Zoning Staff Report

Case Number: ZC-25-088

Site Location: 1812 & 1820 W. Lowden Street

Proposed Use: Auxiliary parking lot

Site
Plan

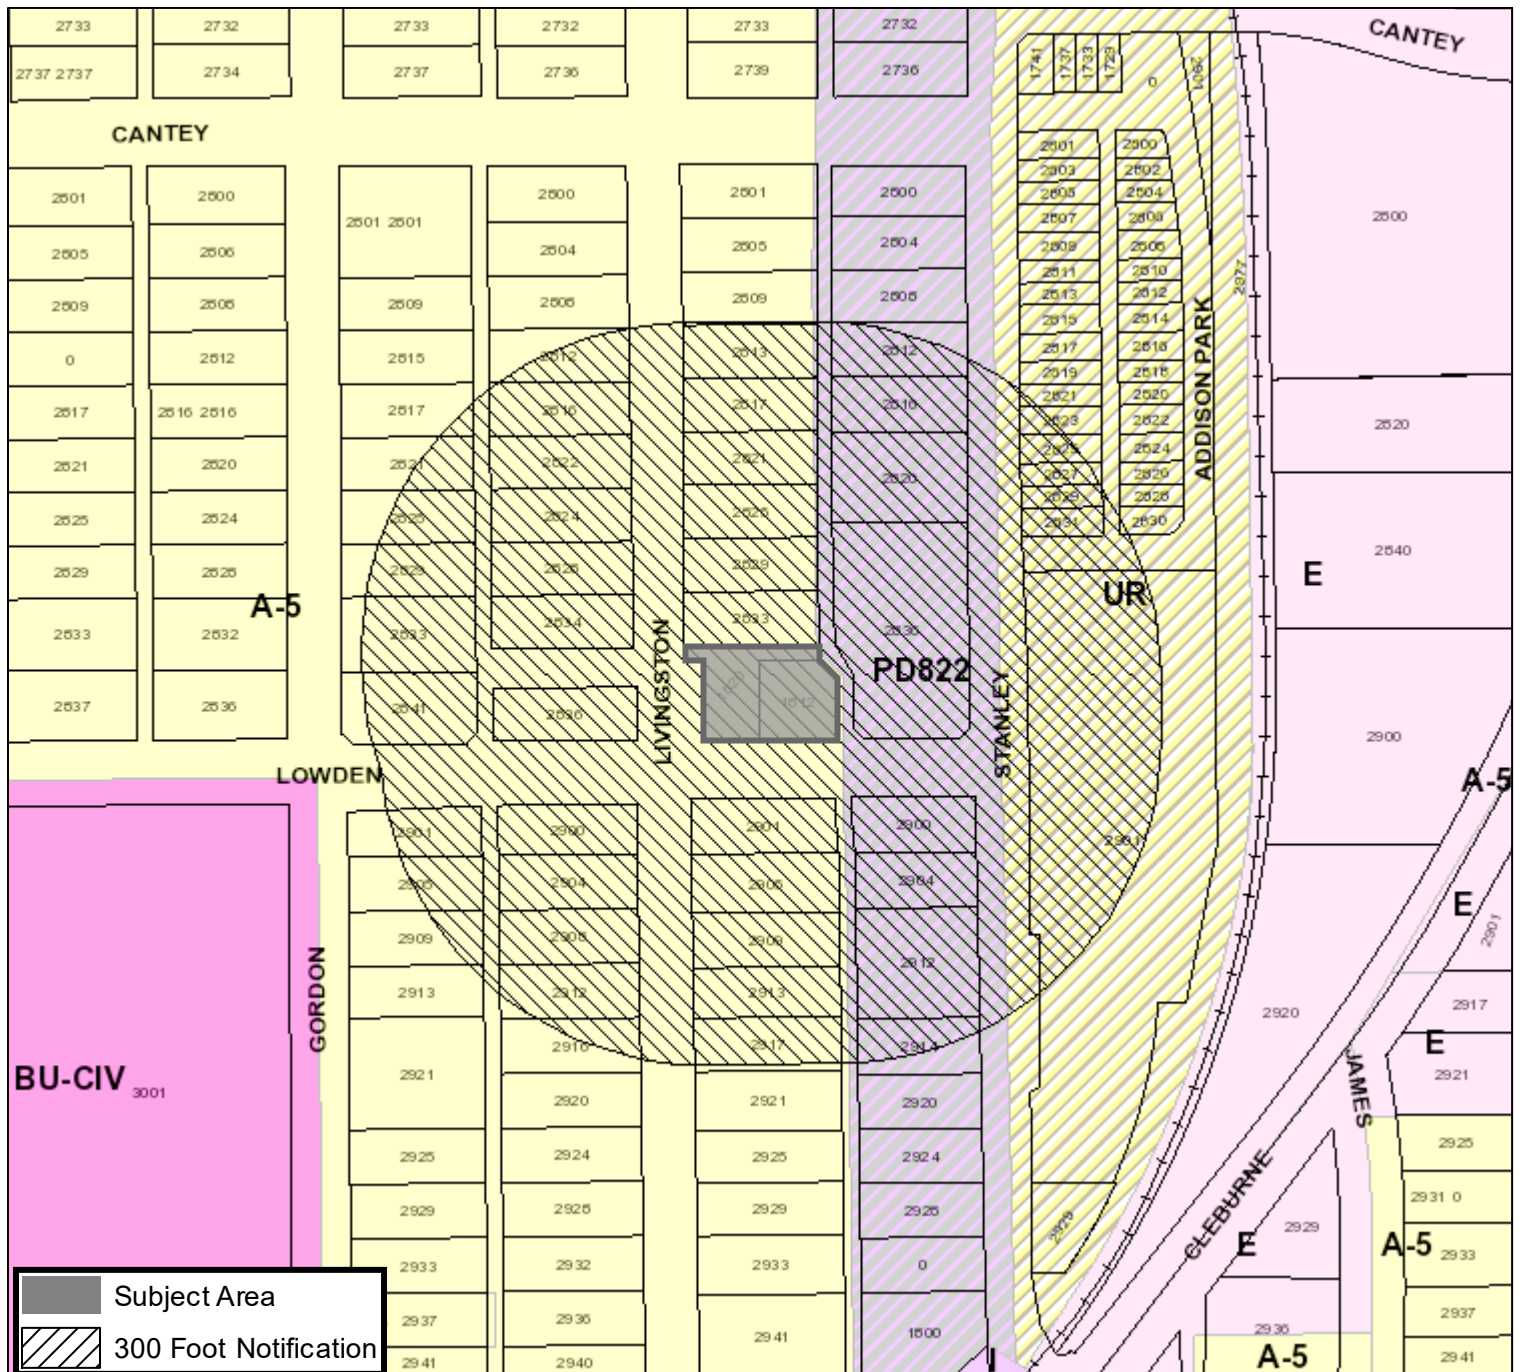
The site plan as submitted is not in general compliance with the Zoning Ordinance regulations. If approved, these comments would need to be addressed prior to ordinance adoption.

1. Add the Site Addresses and full legal descriptions (Subdivision/Block/Lots).
2. Add the title of project or development (in bold letters) in the lower righthand corner of the plan.

3. Add the date of preparation or revision.
4. Add the name, address, and telephone number of person drawing the plan and developer/owner.
5. Add a vicinity map, north arrow, and scale in a reasonable measurement.

6. Label the zoning case number in the lower righthand corner of the plan, below the title.
7. Provide a signature line labeled: "Director of Development Services" with a "Date" line above the project title.

8. The location and label of all existing structures on the site, including those proposed to be removed.
9. Add the label for Note #2 to the drawing.
10. Add the existing wood fence, metal panel, and metal pipe fence symbols to the fencing legend.

11. Solid 6-foot screening fences of wood/masonry/stucco are required on the northern, western, and southern sides. The metal panel and pipe fences are not allowed. Change the fence materials and note both the material proposed and height.

12. Fences are not allowed in front of the house to the north. Pull both the metal panel and pipe fences back to be behind the house's front edge.
13. Paving is not allowed in front of the house to the north. Pull the paving back to be behind the house's front edge.

14. Label the alley Right-of-Way width.
15. Dimension the driveway/aisle width.
16. Label the type(s) of the proposed parking lot surface material in the legend (concrete or asphalt).

17. Add the landscaping areas and sidewalks to the legend.
18. How will the western-most parking spaces turn-around without a bump-out turn-around?
19. Dimension the width and length of parking spaces.

20. Label or note the total number of parking spaces.
21. At least one ADA space will be required, based on the maximum number of parking spaces provided.

22. Show the access ramps and wheel stops/curbing.
23. Show and label all the required setbacks, including the 20-foot supplemental setback on the northern side. Some development waivers may not be needed if the southern front yard meets the required setback.

24. Parking is not allowed in this supplemental setback beyond daylight hours. A development waiver will be required to allow parking for a bar that closes at 2am. Add the note in bold **"This item is requesting a development waiver."**

25. A 5-foot landscaping buffer is required next to the northern property line. Show and label this required landscaping.
26. The majority of the site's landscaping is required to be in the front yard with the widest pavement width. Measure the adjacent street widths and add these pavement widths, then add the required landscaping areas to the appropriate front yard.

27. Add the tree diameter size 4.5 feet from the ground and their species.
28. Note no dumpster or storage will be allowed on-site.
29. Note if lighting will be on-site or not. If lighting is provided, show and label it.

30. If lighting is added, add the note that all lighting will be directed away from residential areas.
31. Auxiliary parking lots are required to be chained and locked over-night. Add the note in bold **"This item is requesting a development waiver."**

32. Show and label all the platted easements.
33. Label the land use and zoning classifications of the surrounding properties in all directions, as well as the subject site.

34. Add the note "This project will comply with [Section 6.301, Landscaping.](#)"
35. Add the note "This project will comply with [Section 6.302, Urban Forestry.](#)"

36. Add the note "All signage will conform to [Article 4, Signs.](#)"
37. Add the note "All provided lighting will conform to the Lighting Code."
38. Informational comment: Signage is not allowed on fencing or gates.

1. Access/use of the alley is subject to review by TDS. If alley is used, it must be paved to City standards, which will require engineered plans approved by the Infrastructure Plan Review Center and a Community Facilities Agreement. The Small-scale infrastructure program may be another route.

2. Driveway on Livingston will not be allowed - does not meet driveway spacing policy (75 feet from intersection minimum). This is especially true if using the alley for access on other side..

3. Access to lot using Alley-only is required. Driveway on Lowden would likely not meet intersection AND driveway spacing requirements.
4. Minimum aisle spacing for 90 degree head in parking is 24 feet. Dimensions not given for parking stalls. May be able to squeeze additional spots into the lot. Chapter 8.4 of the Transportation Engineering Manual for additional guidance.

5. Applicant may be able to pave alley with parkway permit instead of IPRC/CFA or SSIP.
6. Site plan will need to show curbing that will separate parking stalls from alley ROW. A standard driveway from the alley to the parking lot is required.
